ARC **PRODUCT UPDATE** **357** **BULLETIN**

257357 Rev F - Released March 2018

257357F with v1.8 Firmware

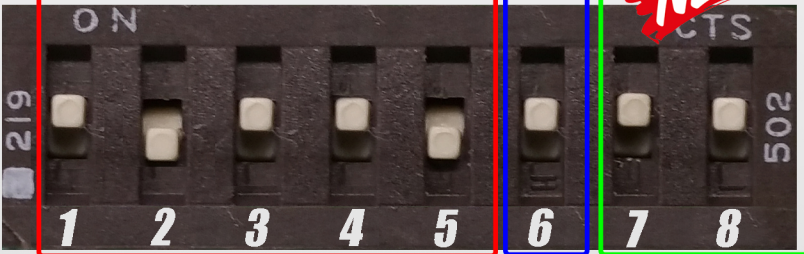
DIP #6
Camera
Mode

DIP Switches
1-5
Configuration

DIP Switches
7 & 8
Default ON
For all current profiles

- Two additional DIP Switches for ultra robust multi- platform CAN Support
- New fault-tolerant output circuit breakers built in on both 12V+ power outputs
- Dead short outputs will not affect module operation. Outputs return to functional status when short is fixed
- v1.8 Firmware adds support for Sync 3 and MyFord Touch Satellite Radio and Camera enable.
*Requires compatible harness FRD54R2
- Audio/visual confirmation of programming completion
- Backwards compatible with all 357 Accessories and harnessing
- New USB VIN-Lock reset compatible.
Software coming soon!
